**SUBDIVISION &
PLANNED UNIT DEVELOPMENT
STAFF REPORT****Date: September 5, 2019****DEVELOPMENT NAME** Leighton Village (Rick Twilley)**SUBDIVISION NAME** Leighton Village**LOCATION** East terminus of Leighton Place.**CITY COUNCIL
DISTRICT** District 4**AREA OF PROPERTY** 30 Lots / 12.8 ± acres**CONTEMPLATED USE** Subdivision to amend the previously approved Phase Two subdivision with 30 lots and request reduced side and front yard setbacks. Planned Unit Development Approval to allow a proposed subdivision with reduced front and side yard setbacks**TIME SCHEDULE
FOR DEVELOPMENT** Immediately.**ENGINEERING****COMMENTS** **Subdivision:** FINAL PLAT COMMENTS (should be addressed prior to submitting the FINAL PLAT for review and/or signature by the City Engineer):

SITE PLAN

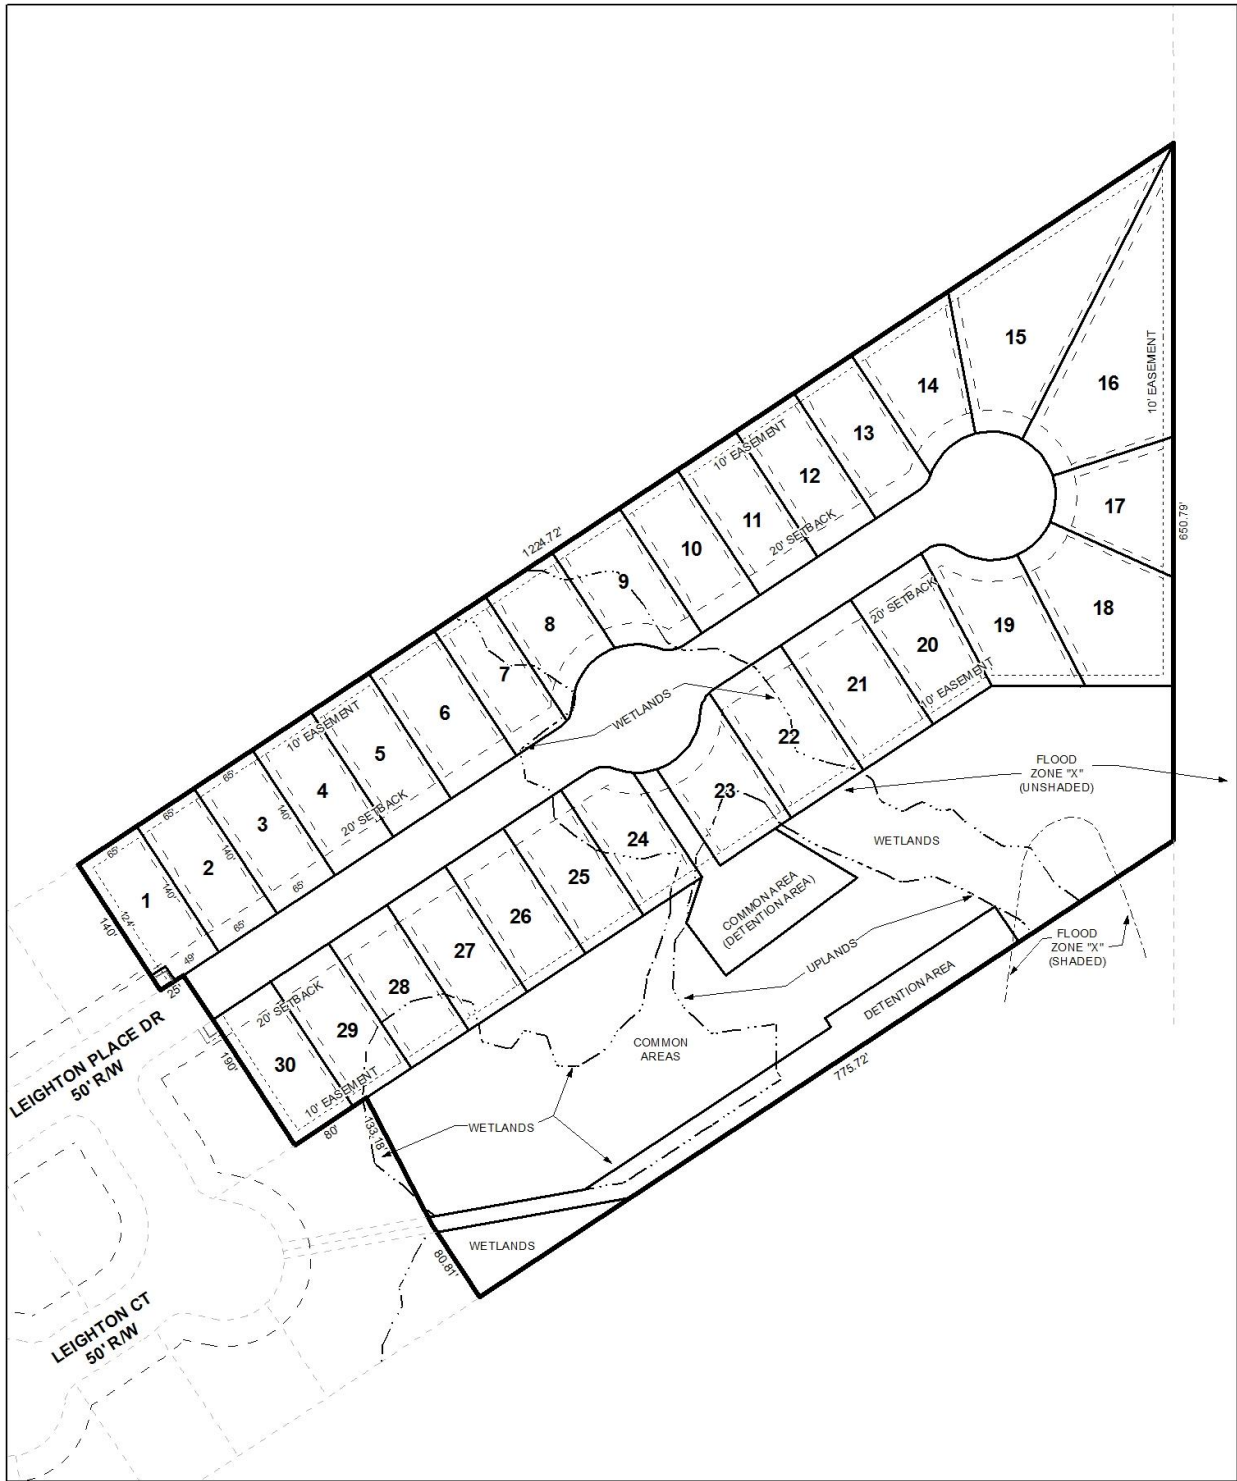
- B. Check and revise the written description for the proposed 30 LOT subdivision. It appears to include LOT 31 which is not shown as part of the subdivision boundary and is not included in the application.

- C. Revise the written subdivision boundary description to include only the BOUNDARY of the subdivision. It appears to include all the LOTS and Common Areas but not the proposed ROW.

- D. Show an MFFE for each LOT located within the 2019 Preliminary X(S) flood zone. According to the preliminary 2019 FEMA map a number of lots within this parcel are proposed to be located within an x (shaded) flood zone when the maps are adopted and become effective. Any change to a flood zone may necessitate additional City of Mobile code requirements including, but not limited to, enforcement of the base flood elevation.

Both the preliminary plat and PUD site plan illustrate a 30-lot subdivision. Though the applicant has indicated that there will not be an entrance gate, there appears that a gate is still illustrated on the preliminary plat. If approved, the Final Plat and PUD site plan should both indicate the elimination of the entrance gate.

The proposed lots front Leighton Place Drive, a minor street requiring a 50' right-of-way width. The preliminary plat illustrates a compliant 50' right-of-way width and should be retained on the Final Plat, if approved.

A 20-foot minimum building setback is depicted on the preliminary plat along Leighton Place Drive. If approved, the 20-foot setback should be retained on the Final Plat.

- 1) Retention of the 50' right-of-way width for Leighton Place Drive;*
- 2) Illustration of the minimum building setback for each lot;*
- 3) Retention of lot size information in both square feet and acres;*

- 2) *Retention of the lot sizes in square feet and acres;*
- 3) *Retention of 20' minimum building setback lines along Leighton Place Drive;*
- 4) *Retention of the 50' right-of-way width on PUD site plan;*

- 5) *Placement of a note on the PUD site plan stating that, as a condition of the continuation of private street status, the private access gate must remain operational and in use*

SITE PLAN

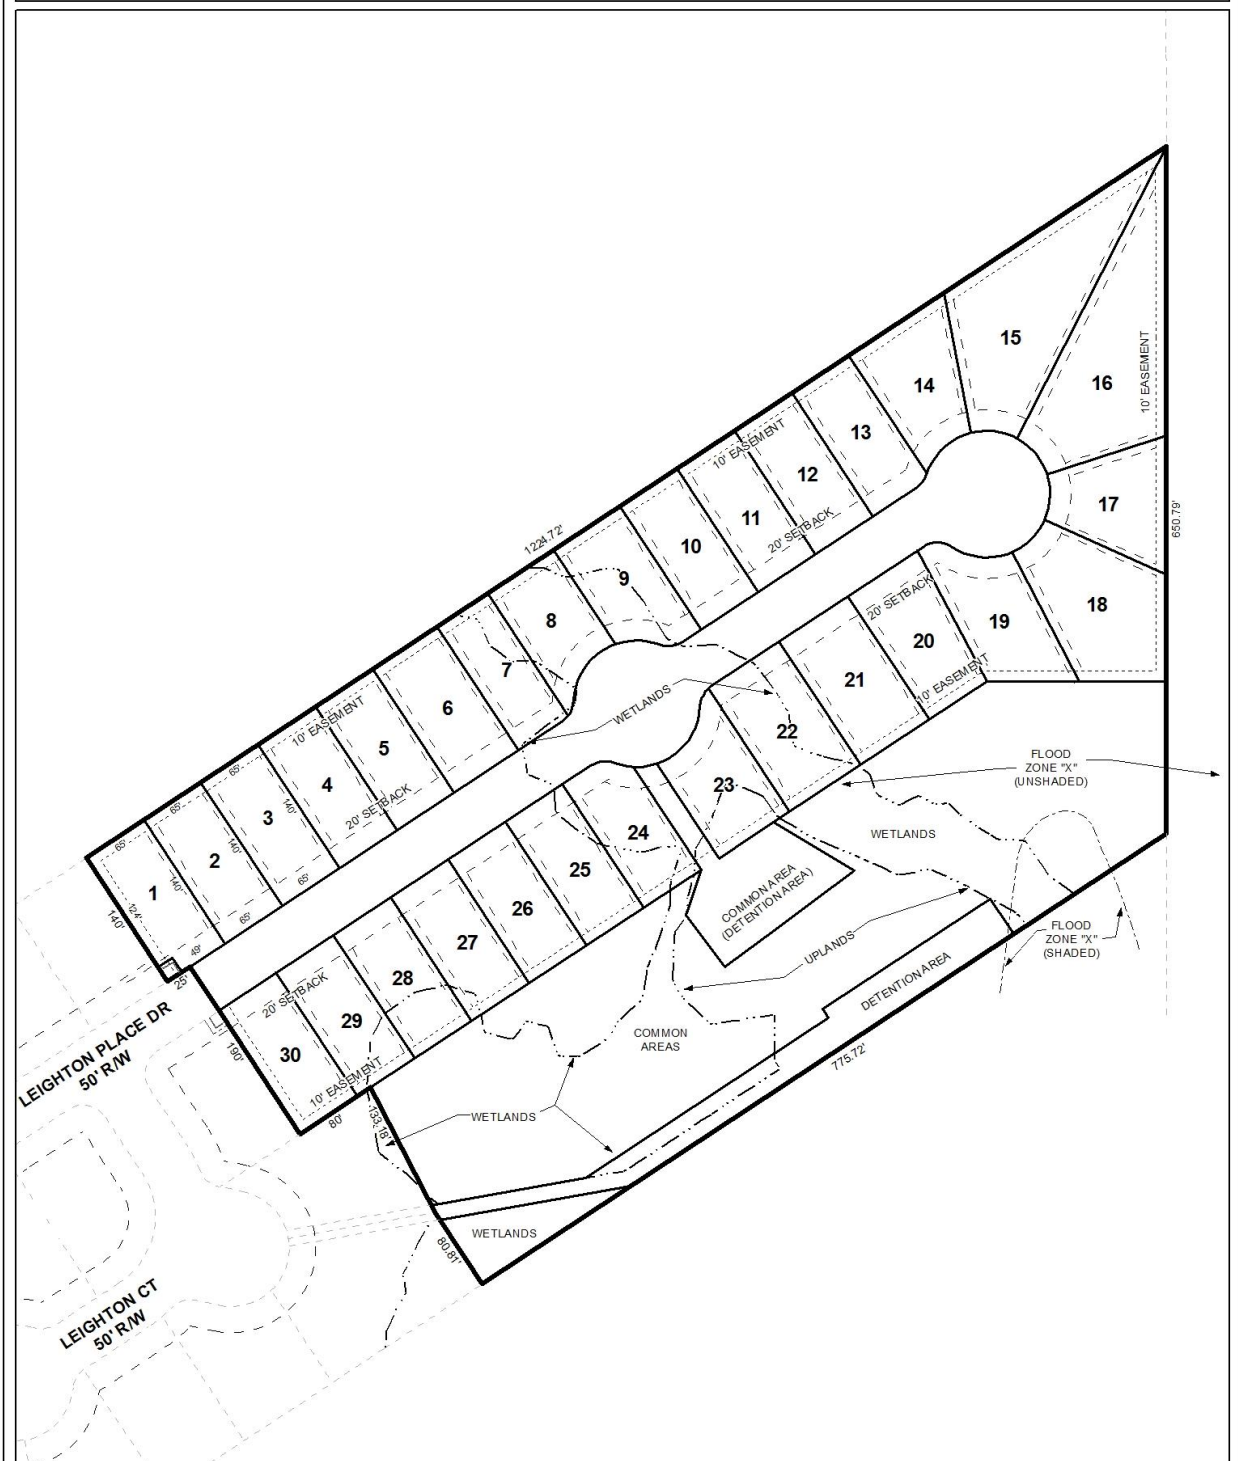
- 1. Retain NOTES 8-15 as shown on the revised drawing (8-8-19) submitted.
- 2. Label the revised drawing (8-8-19) that was submitted as PUD SITE PLAN.

- 8) *Compliance with Engineering comments: “(1. Retain NOTES 8-15 as shown on the revised drawing (8-8-19) submitted. 2. Label the revised drawing (8-8-19) that was submitted as PUD SITE PLAN)”;*
